PROJECT # 2019-179  
DATE: 28 AUGUST 2020

△ PLAN REVIEW 11.03.2020  
△ PLAN REVIEW 03.19.2021  
△ PLAN REVIEW 05.10.2021

MCKINNEY LANE APARTMENTS PHASE II  
RUSSELL DRIVE & MCKINNEY LANE  
LEBANON, OREGON 97331

△  
1  
E2.01  
BLDG "C"  
FIRST FLOOR - LIGHTING PLAN  
SCALE: 1/4" = 1'-0"

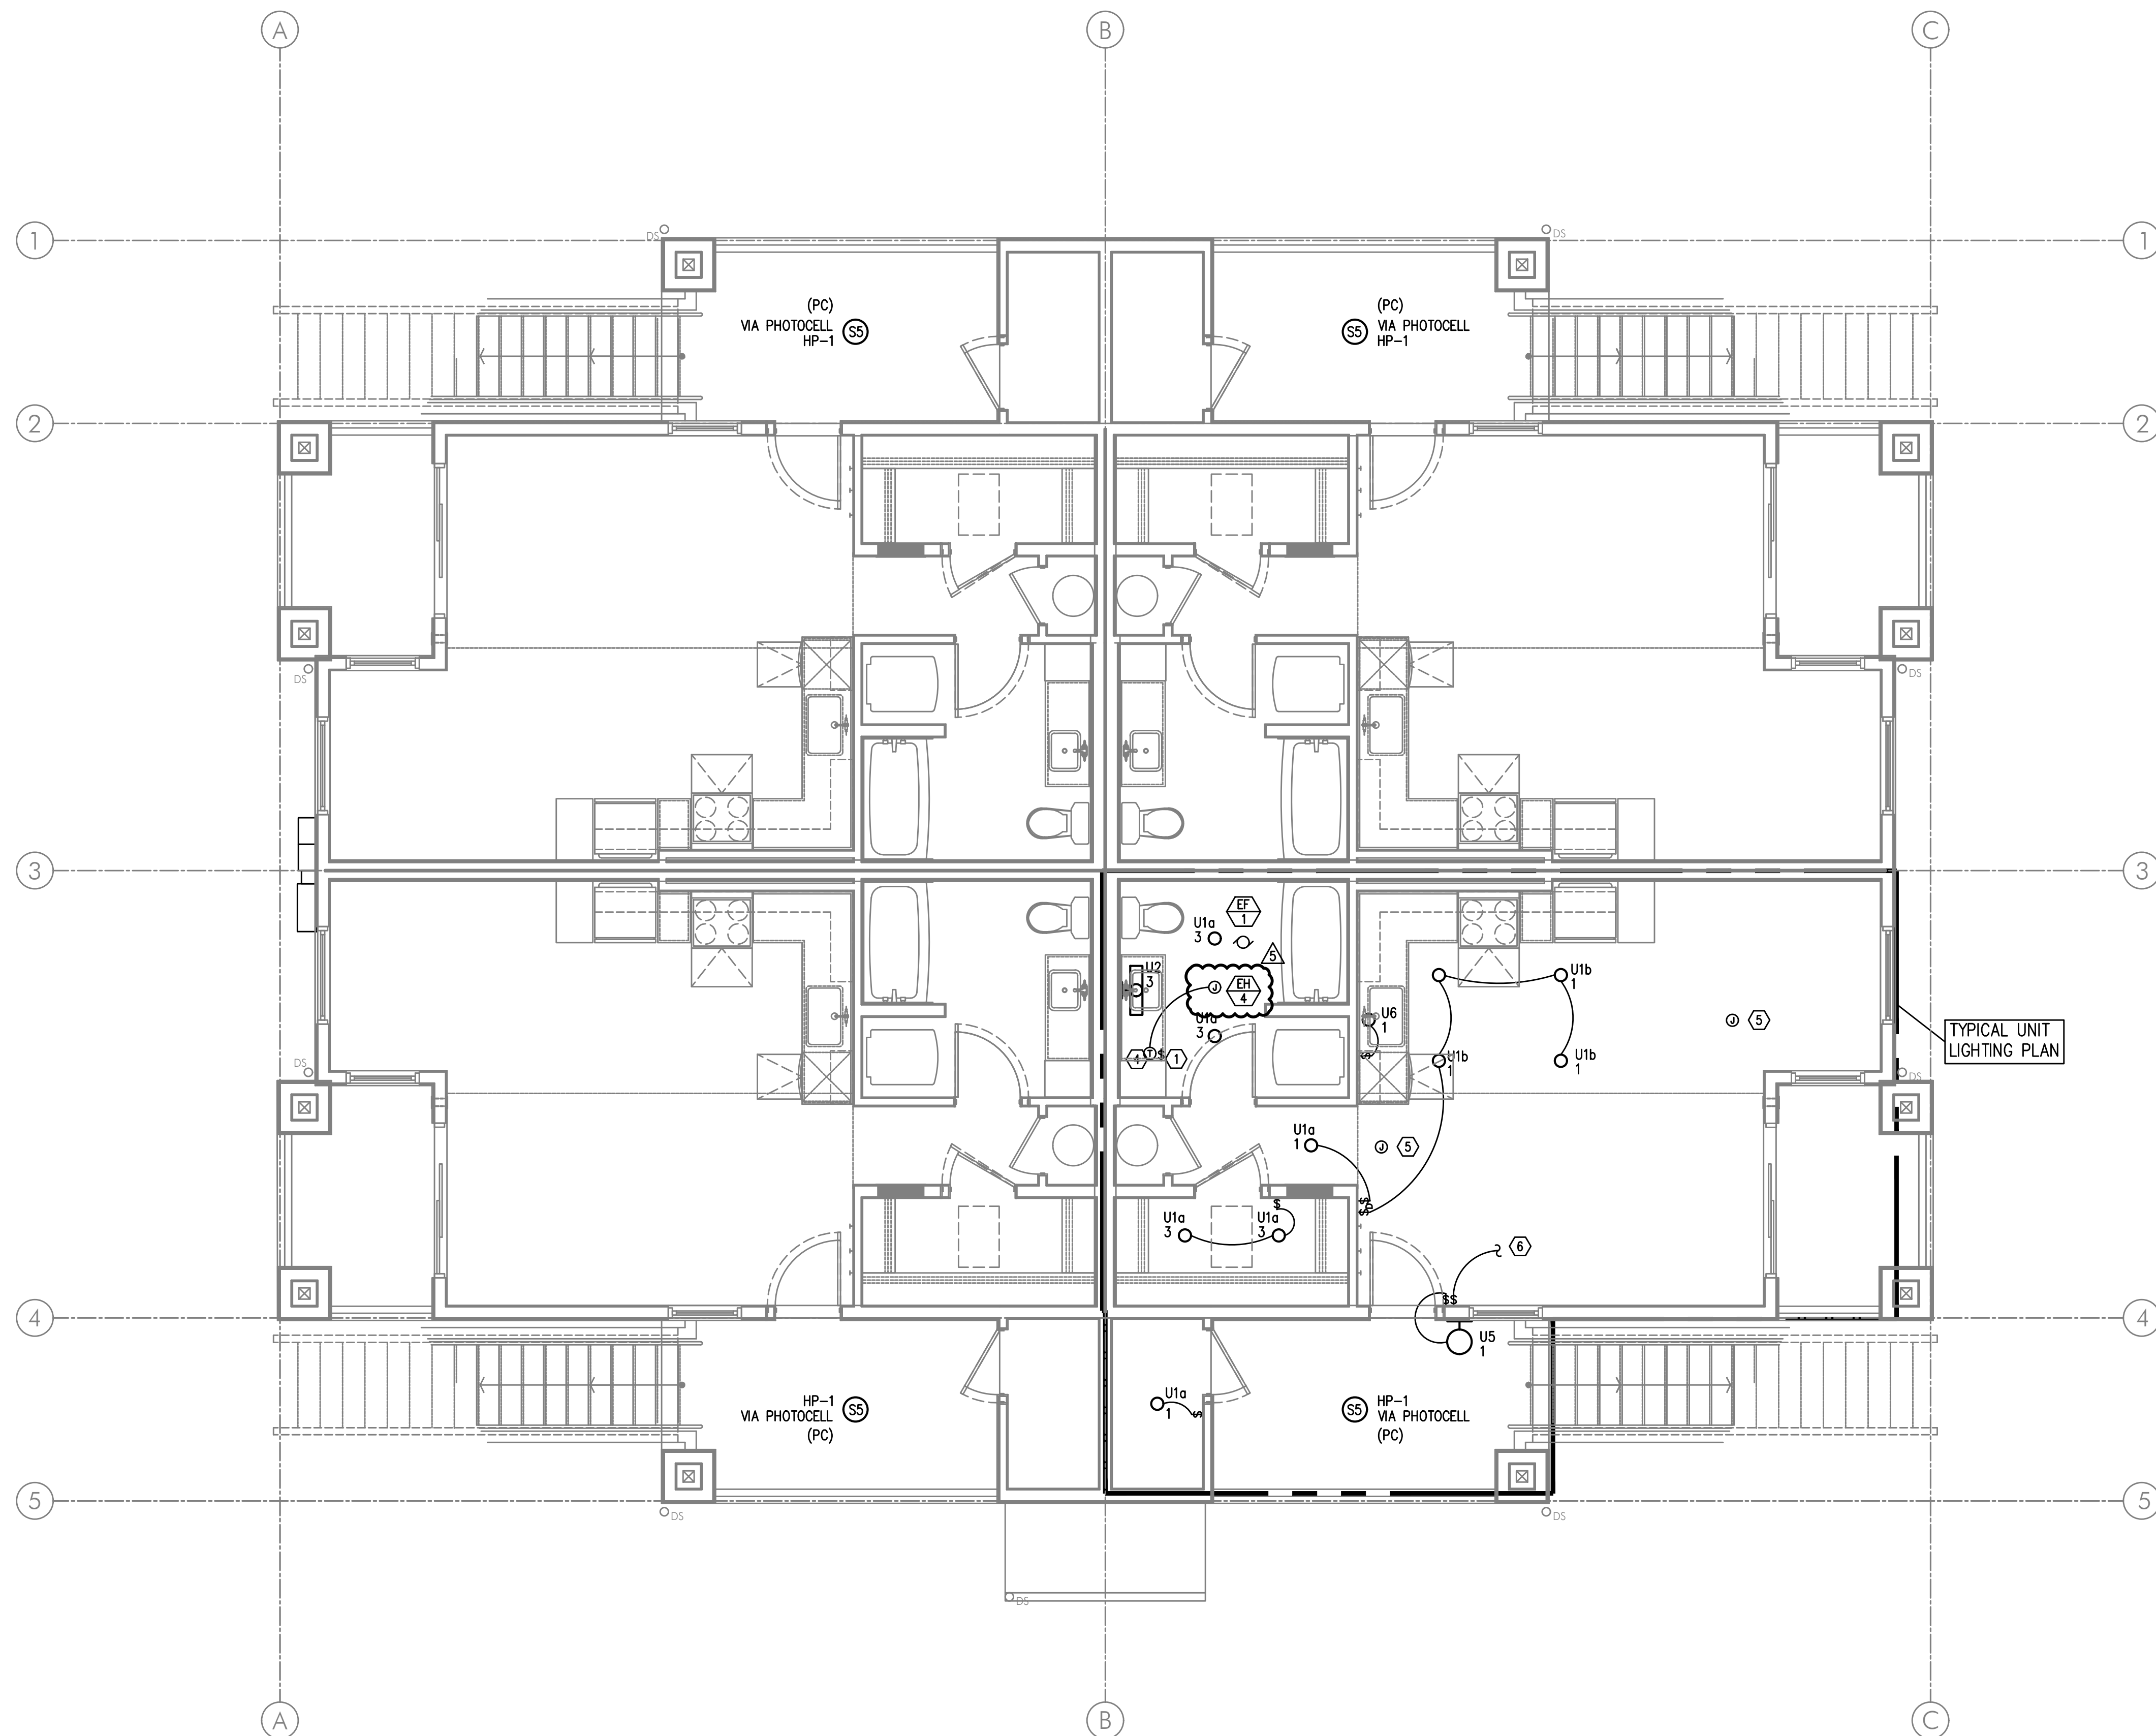
- △ B. ALL DISCREPANCIES SHALL BE BROUGHT TO THE ATTENTION OF THE ARCHITECT IMMEDIATELY UPON DISCOVERY.
- C. REFER TO SHEET E1.21 FOR LIGHT FIXTURE SCHEDULES.

- △ D. THE ELECTRICAL CONTRACTOR SHALL REFER TO THE ARCHITECTURAL AND/OR INTERIORS PLAN SETS FOR DIMENSIONED LOCATIONS, MOUNTING HEIGHTS AND FINISHES OF DEVICES AND FIXTURES.

- J. REFER TO ARCHITECTURAL REFLECTED CEILING PLANS FOR EXACT FIXTURE LOCATIONS (DIMENSIONS).
- △ K. CEILING HEATERS SHALL BE PROVIDED AND INSTALLED BY THE ELECTRICAL CONTRACTOR. INSTALLATION TO INCLUDE WIRING AND DEVICES FOR REMOTE THERMOSTATS. CONSULT ARCHITECTURAL PLANS FOR EXACT LOCATIONS. REFER TO E1.11 FOR MORE INFORMATION REGARDING THE WALL HEATERS.

△  
**1**  
**E2.02** BLDG 'C'  
SECOND FLOOR — LIGHTING PLAN  
SCALE: 1/4" = 1'-0"

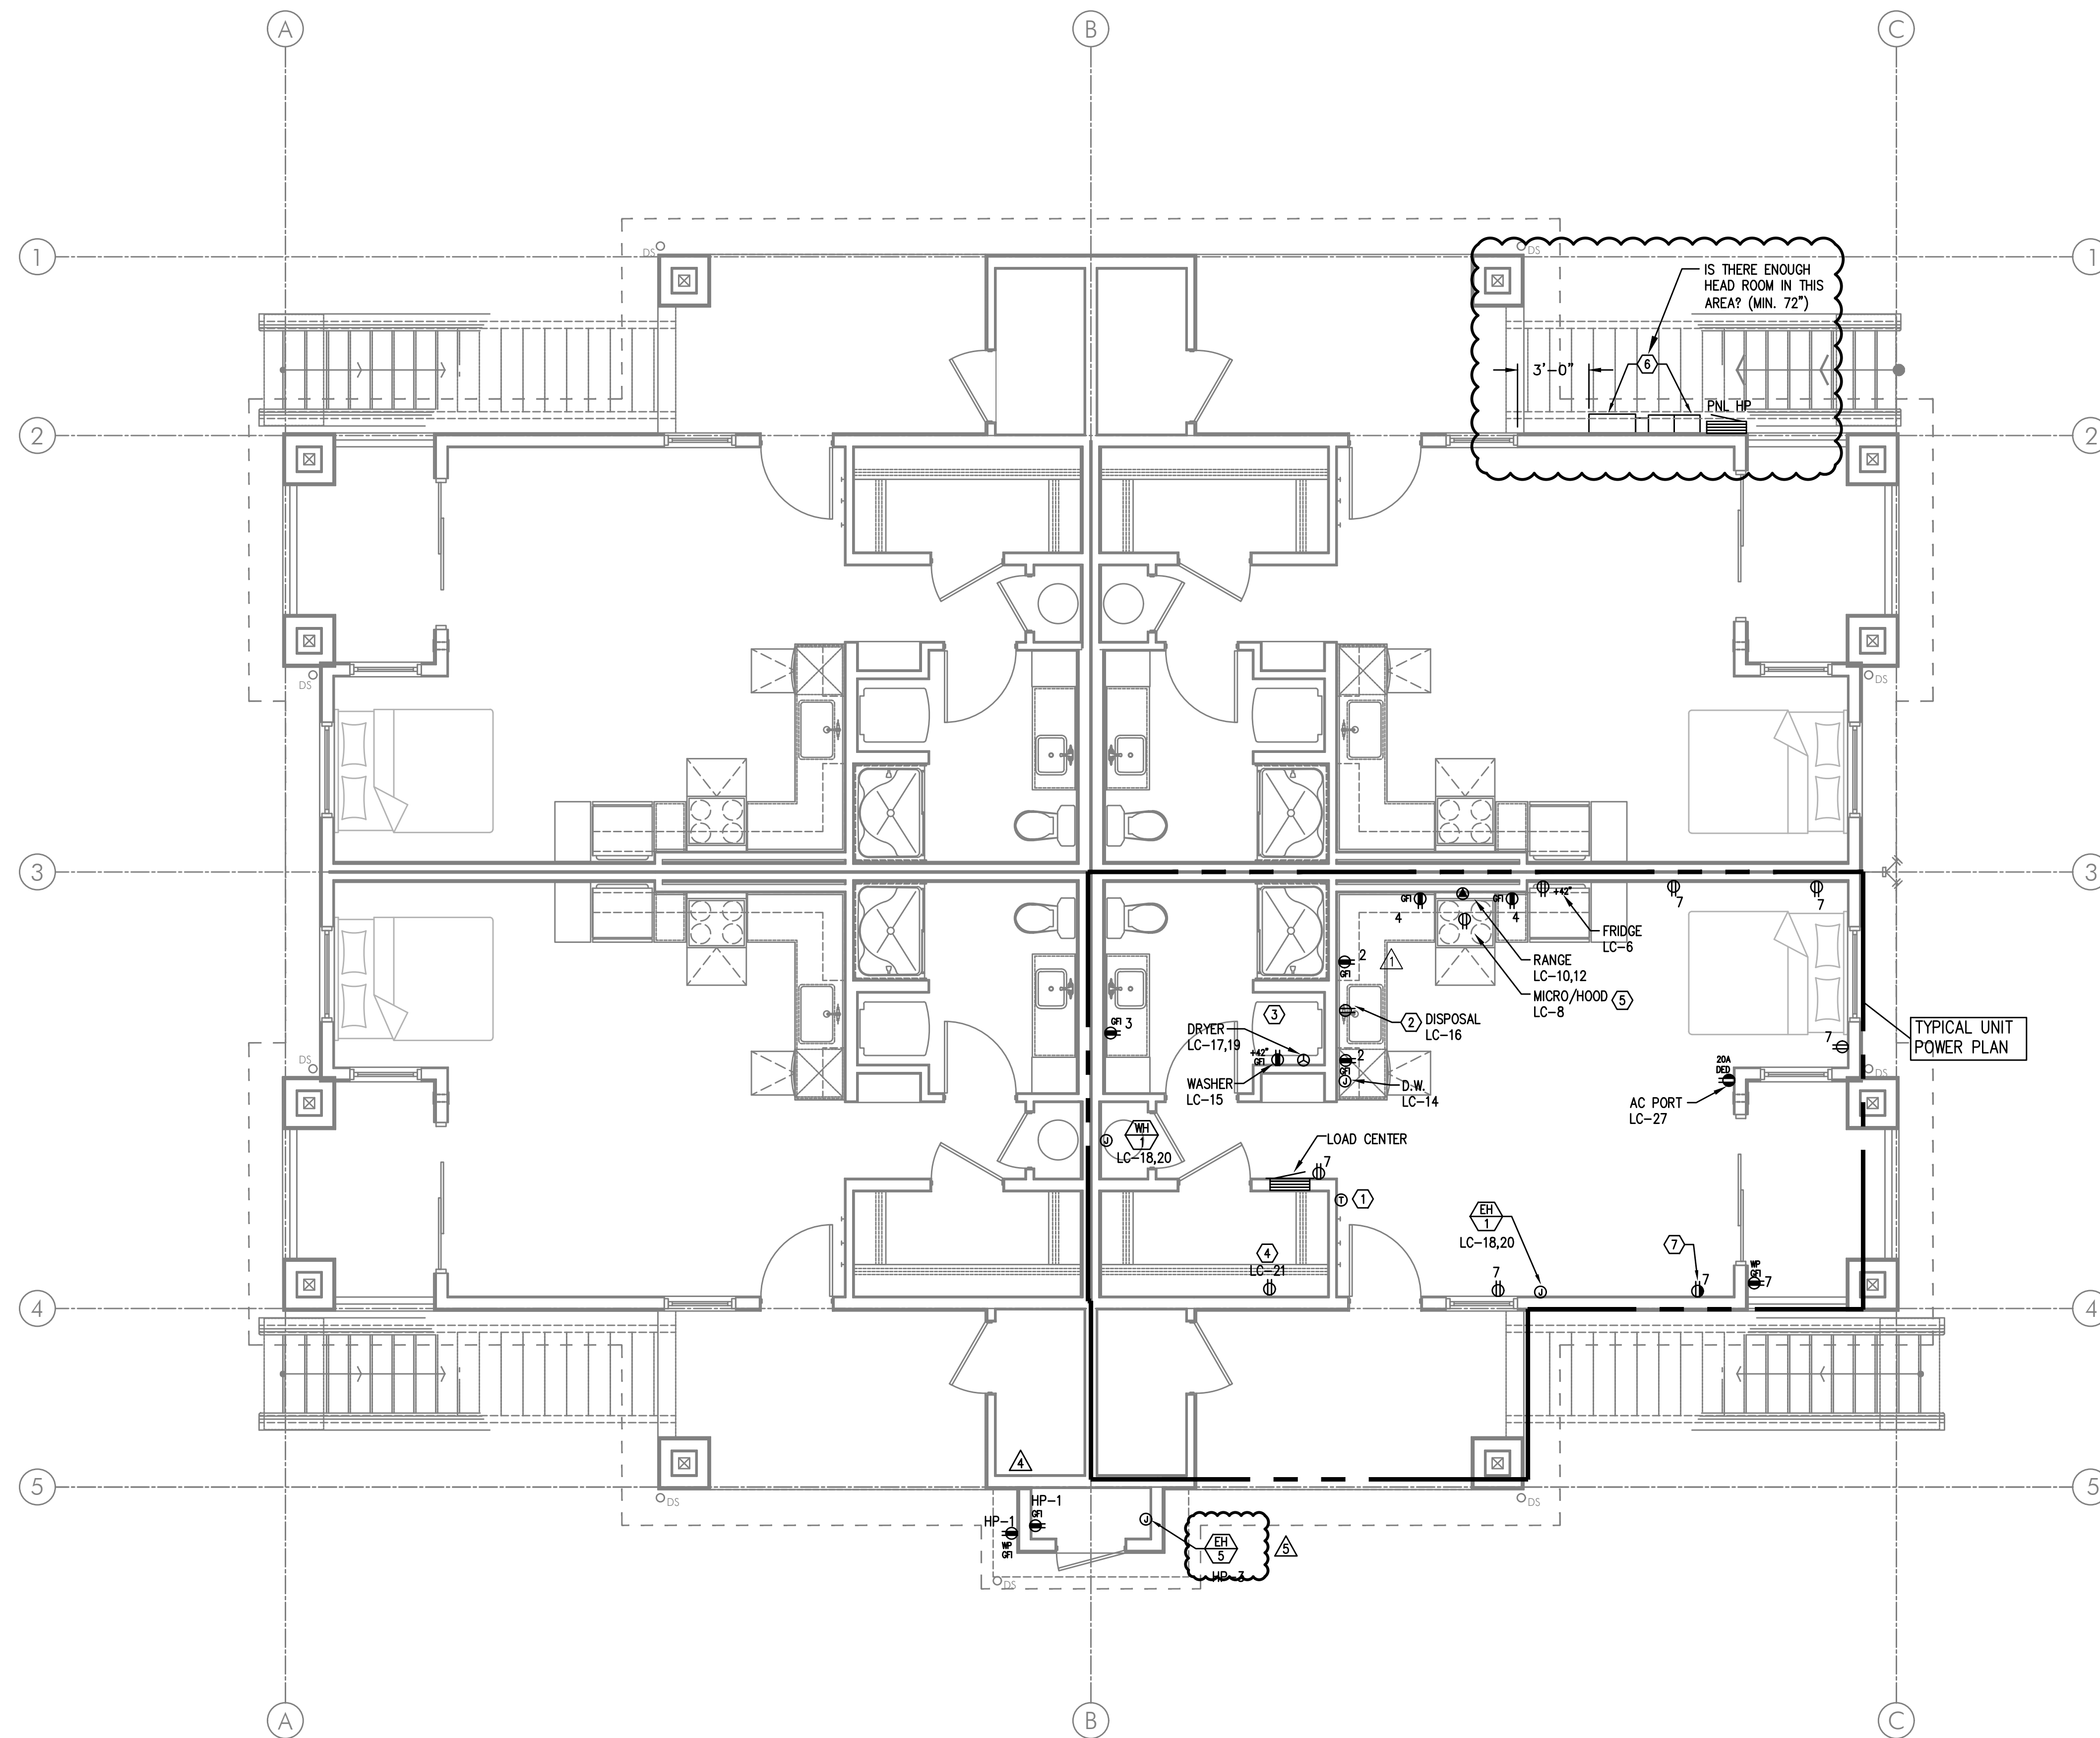
- △ B. ALL DISCREPANCIES SHALL BE BROUGHT TO THE ATTENTION OF THE ARCHITECT IMMEDIATELY UPON DISCOVERY.
- C. REFER TO SHEET E1.21 FOR LIGHT FIXTURE SCHEDULES.

- △ D. THE ELECTRICAL CONTRACTOR SHALL REFER TO THE ARCHITECTURAL AND/OR INTERIORS PLAN SETS FOR DIMENSIONED LOCATIONS, MOUNTING HEIGHTS AND FINISHES OF DEVICES AND FIXTURES.

- △ CEILING HEATERS SHALL BE PROVIDED AND INSTALLED BY THE ELECTRICAL CONTRACTOR. INSTALLATION TO INCLUDE WIRING AND DEVICES FOR REMOTE THERMOSTATS. CONSULT ARCHITECTURAL PLANS FOR EXACT LOCATIONS. REFER TO E1.11 FOR MORE INFORMATION REGARDING THE WALL HEATERS.
